NOTICE TO ALL FIRMS

Date: April 21, 2026
To: All Prospective Bidders
From: Maria De Los Angeles Lopez
Purchasing Agent
Re: Addendum Number 1
IFB # C1744 – COED Hall Apartment and Corridor Painting (Floors 11-15)

PROJECT:
COED RESIDENCE HALL
APTS. & CORRIDOR PAINTING
FLOOR 11-15
230 W 27TH STREET
NEW YORK, NY 10001

1 FLOORS 11-15 FINISH PLAN
A-800 SCALE: 3/16" = 1'-0"

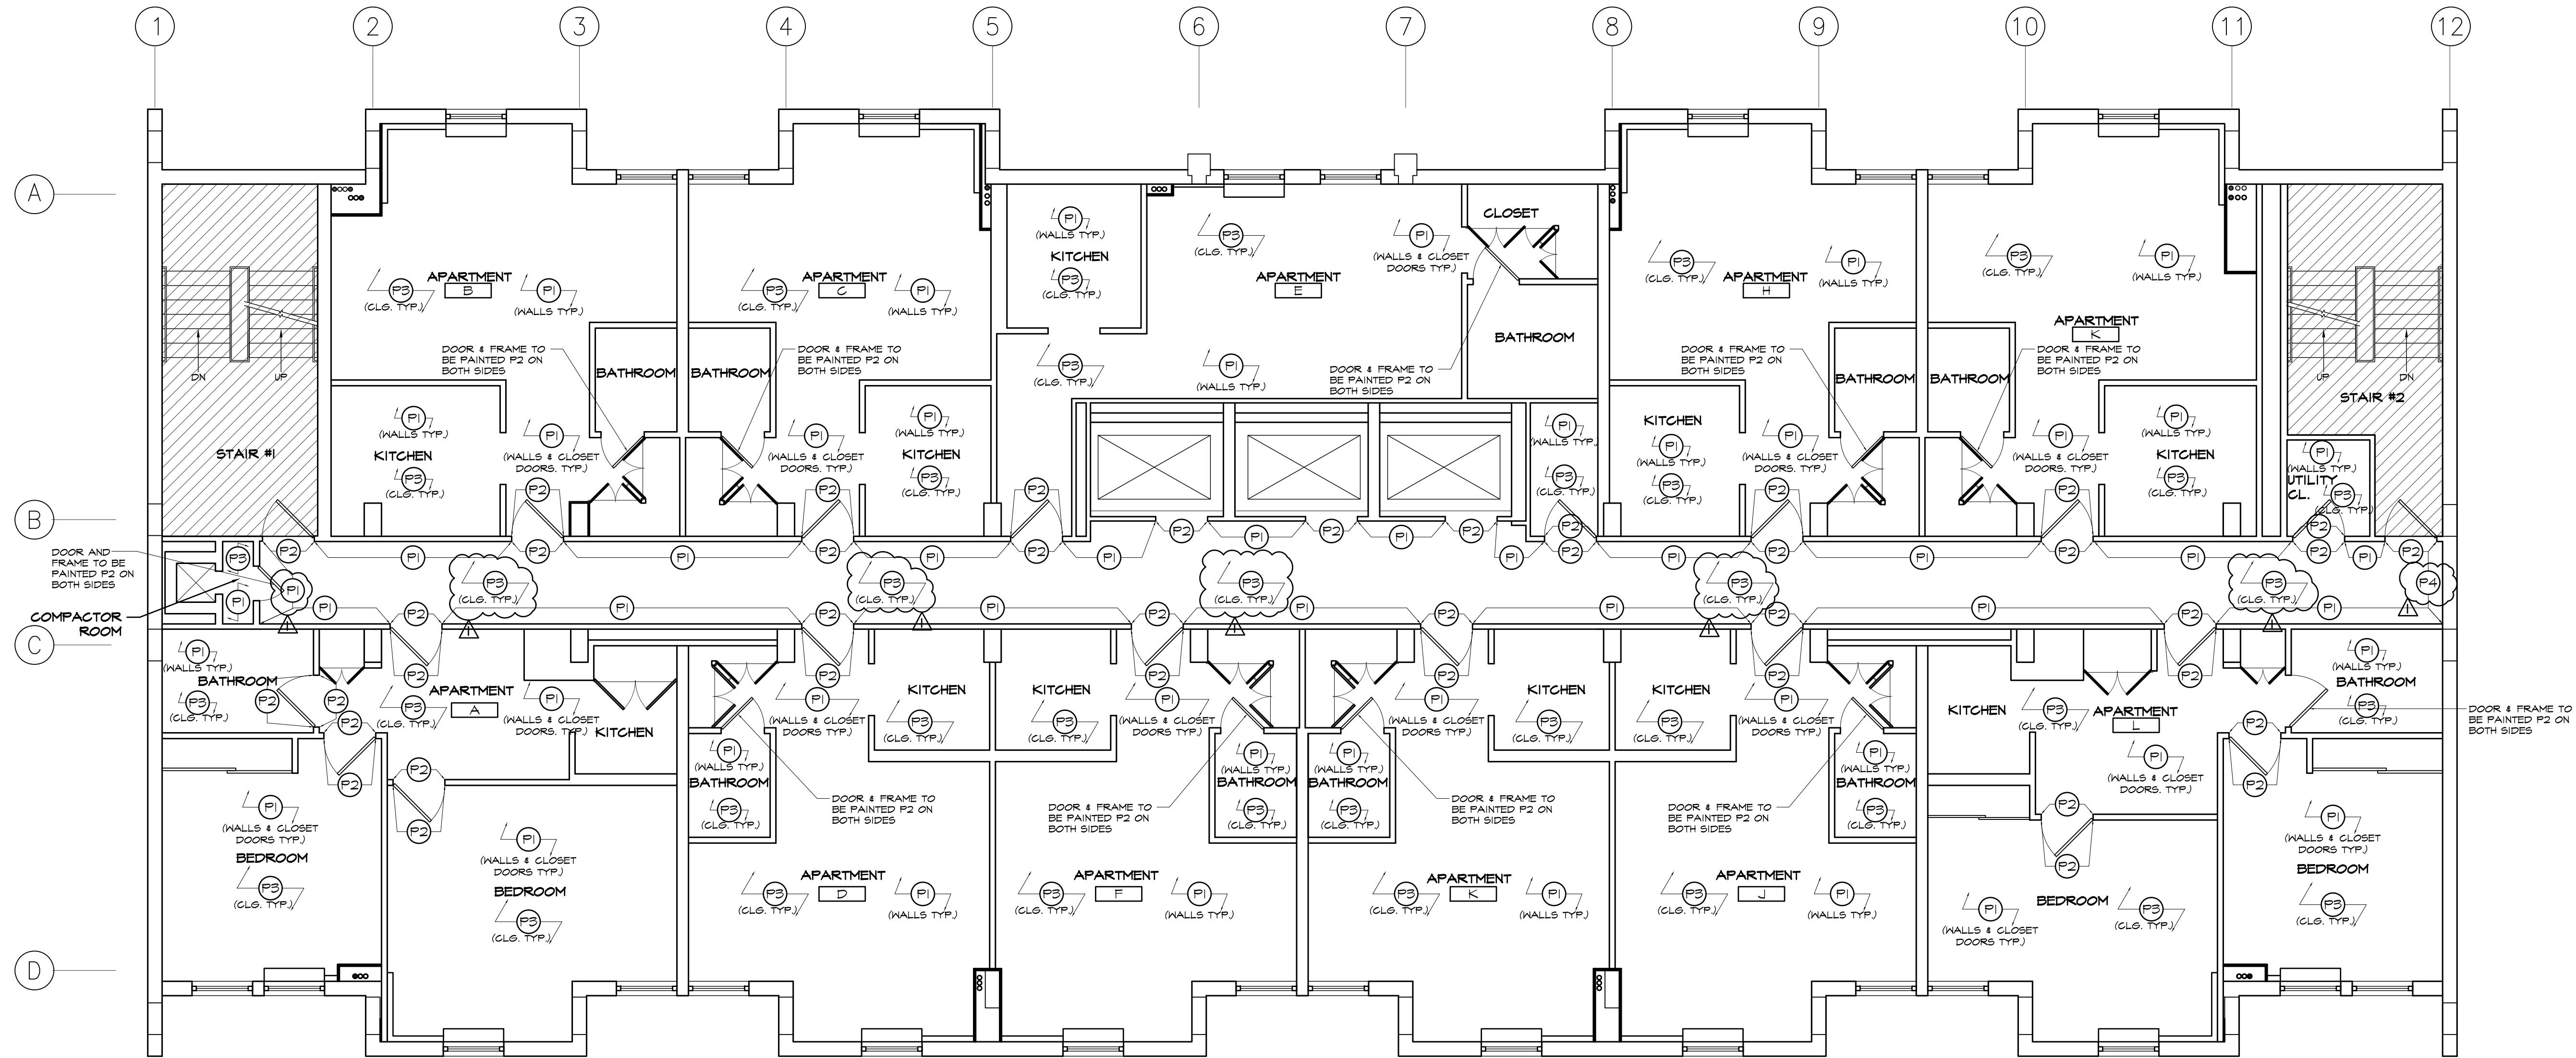
- Q1. Will the corridor ceiling and dorm room ceilings get painted?
- A1. Yes both the corridor ceiling & room ceilings will be painted P3. Refer to revised A-800 Sheet. (See attached).
- Q2. Could you please clarify what information should be entered in the three blank fields highlighted in red? Kindly refer to the attached document for reference.
